Re: Renewable Energy Approval (REA) Application for the proposed Sol-luce Kingston Solar PV Project

Kingston Solar LP (the "Proponent") has prepared this letter to provide the Ministry of the Environment (Ministry) with additional clarity regarding Ministry's comments with respect to the Renewable Energy Approval (REA) submission and specific REA reports for the proposed Sol-luce Kingston Solar PV Project.

The following are Ministry's comments provided on December 5, 2012 and Proponent's responses:

FIGURE: 2

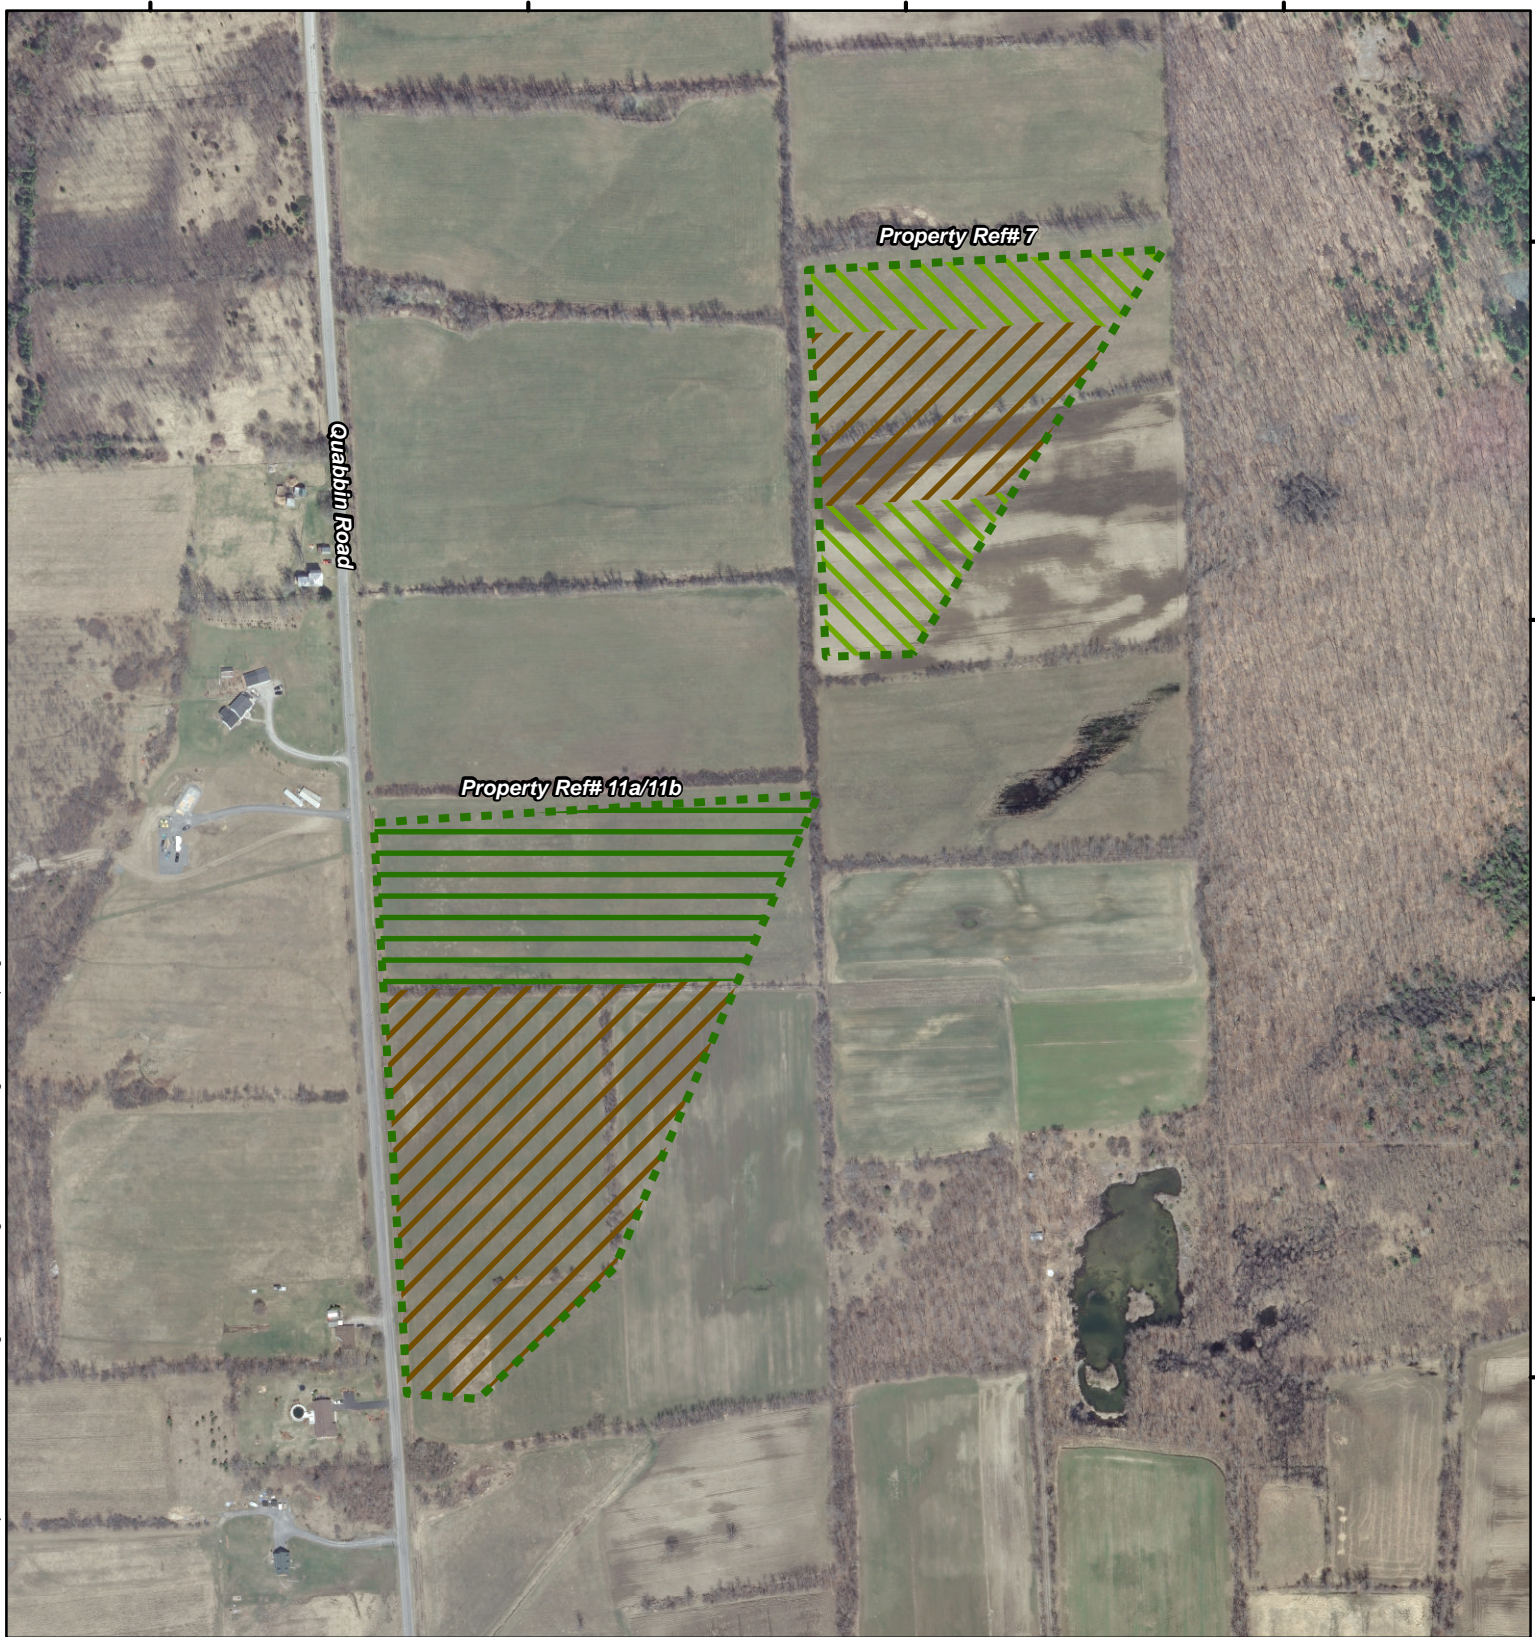
1. Property Reference #7 on "Figure 2" of the most recent maps sent, has class 2P lands inside your development area.
2. In "Figure 1" of the most recent maps you sent, there appears to be a section of Class 1 lands at the top of the development area. This land appears above class 5R lands (reclassified as 5R after the soil study). You mention in your previous email that it was reclassified from Class 1 to Class 4R and 5R which appears to be the case for most of the property, so maybe you can clarify the uppermost part of the development area appearing to be Class 1.

FIGURE:
 DATE: June 2012

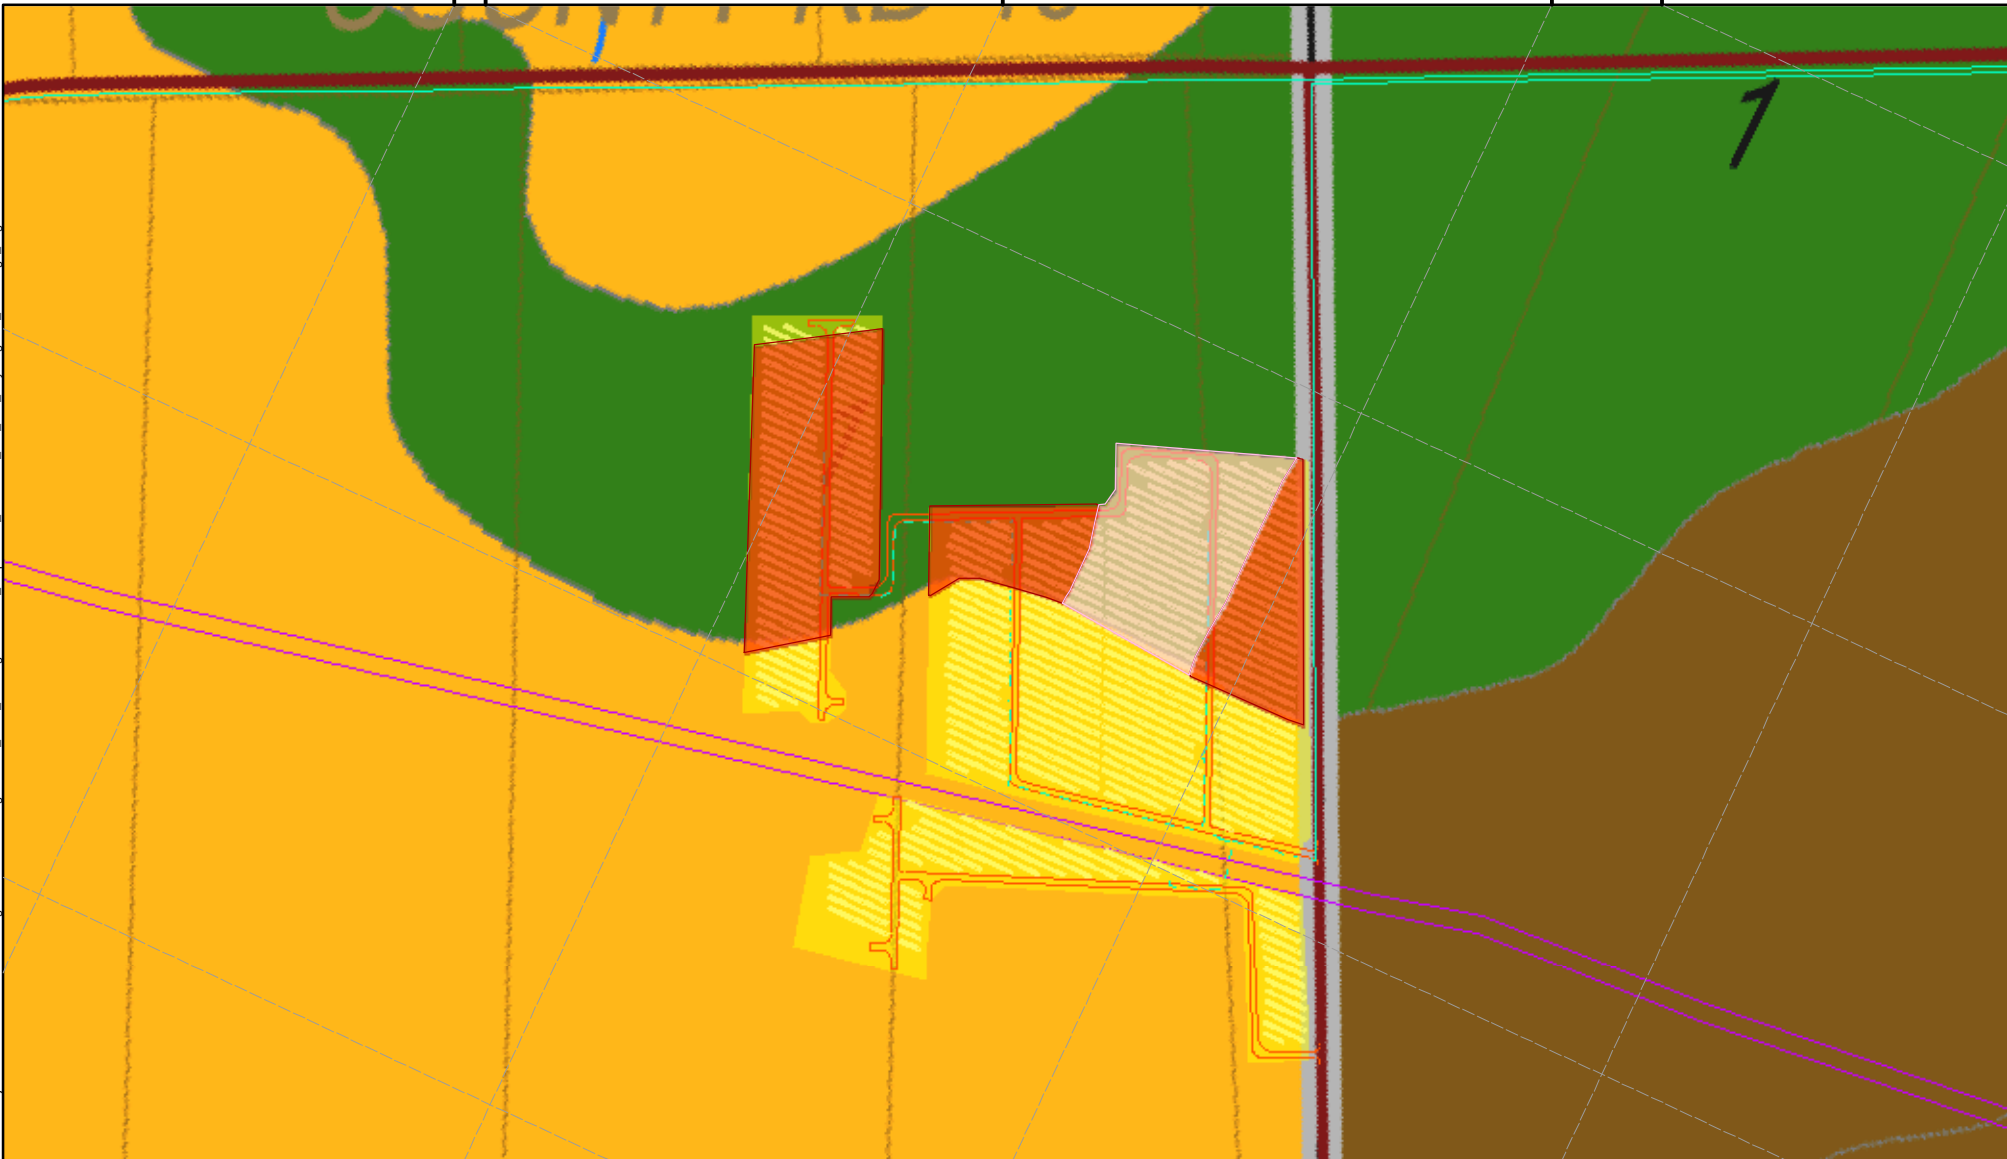
Regarding the upper most part of the development area on Fig 1, currently our consultants are clarifying this section, I will get back to you as soon I receive their feedback.

Thanks, this is what I was hoping to see. If you turn off the CLI map layer will you be able to show what the soil classification for each part of the development area is? I noticed in Figure one there are sections of the development area that are plain yellow, am I to assume that the lands in these yellow areas are classified the same as the CLI map underneath it?

Yes in figure one (attached) the yellow sections represent areas that are classified the same as the CLI map underneath it, which in this case is CLI 6 (marginal land). Additionally the red/pink sections represent the reclassification from class 1 to marginal (4R and 5R) based on the soil studies (report) that was generated late last year.
